January 27, 2021

ADDENDUM 3 – ALL TRADES

Proposed Union Road Car Wash
West Seneca, New York

3 ENLARGED DOG WASH AREA
SCALE: 1/4" = 1'-0"

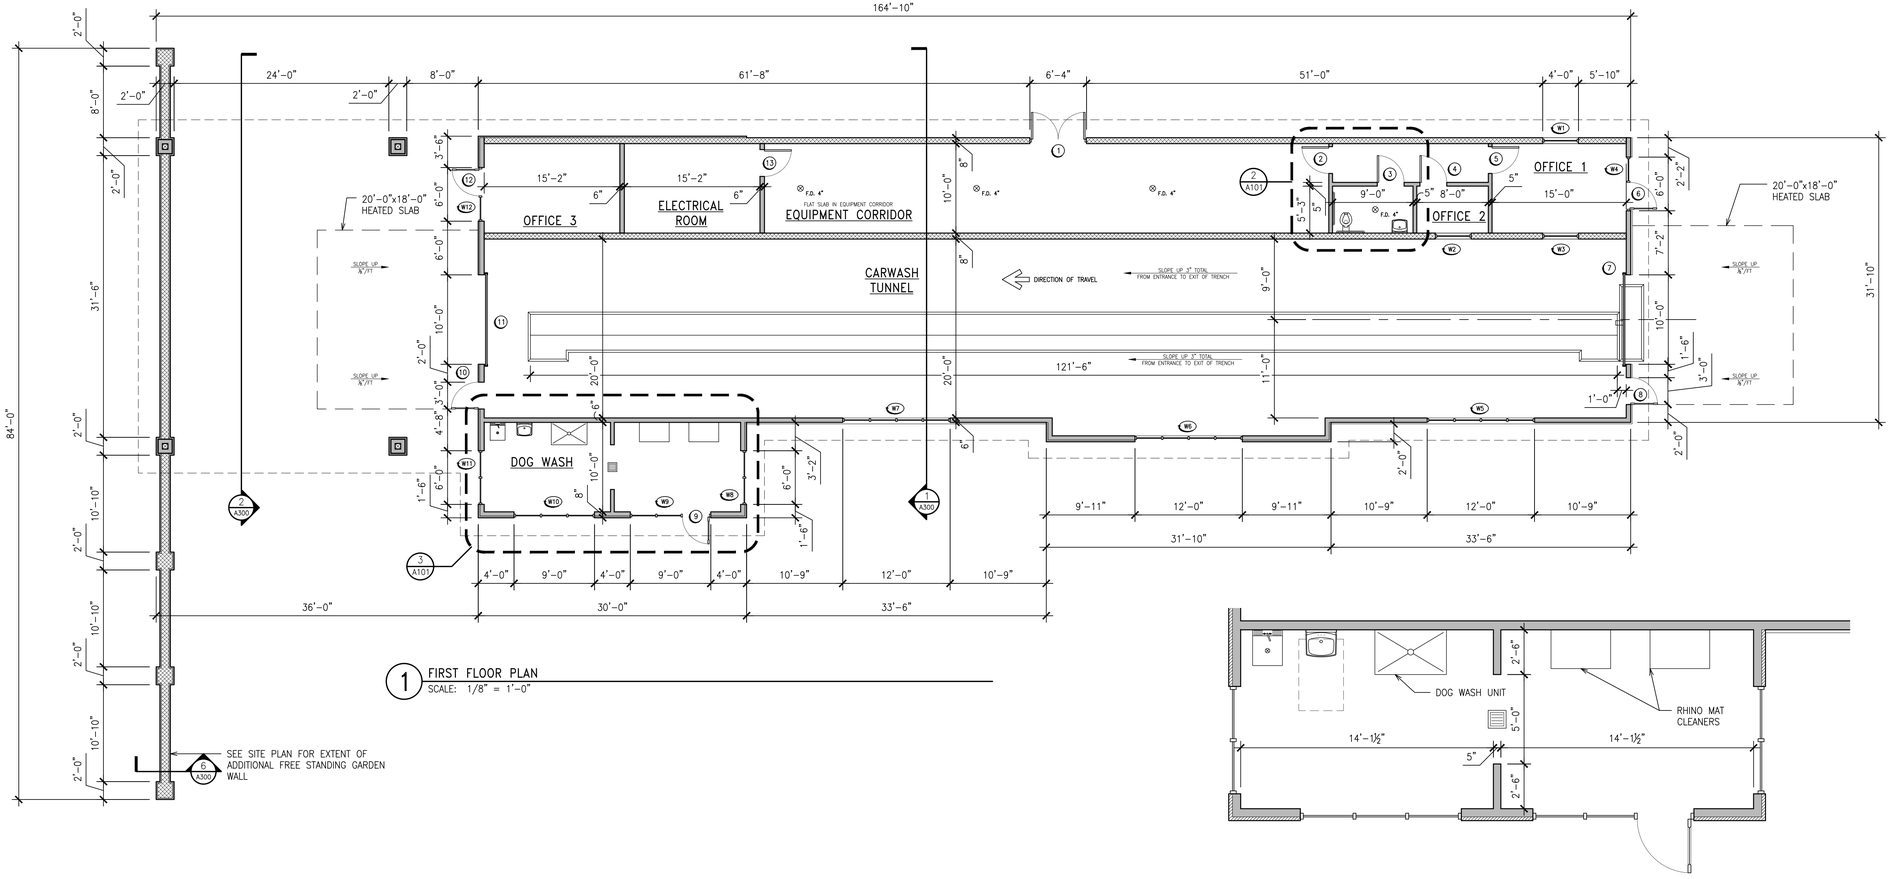
Add revised drawing A101 to bid set (enlarged dog wash plan)

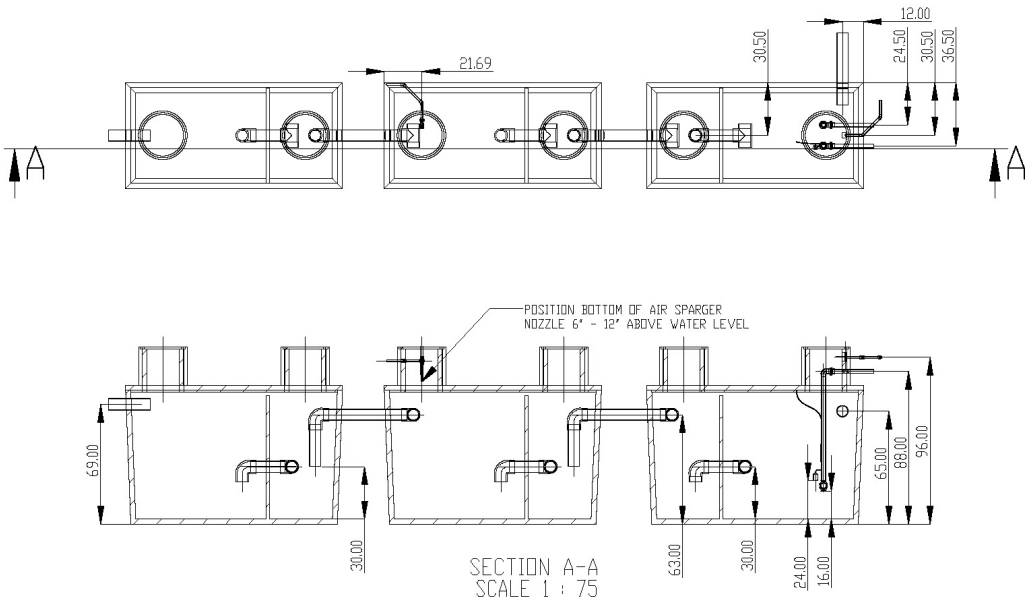
Attached please find optional underground tank system. This tank is 2/3 and 1/3 chambers as opposed to the 1/2 and 1/2 tank originally called for.
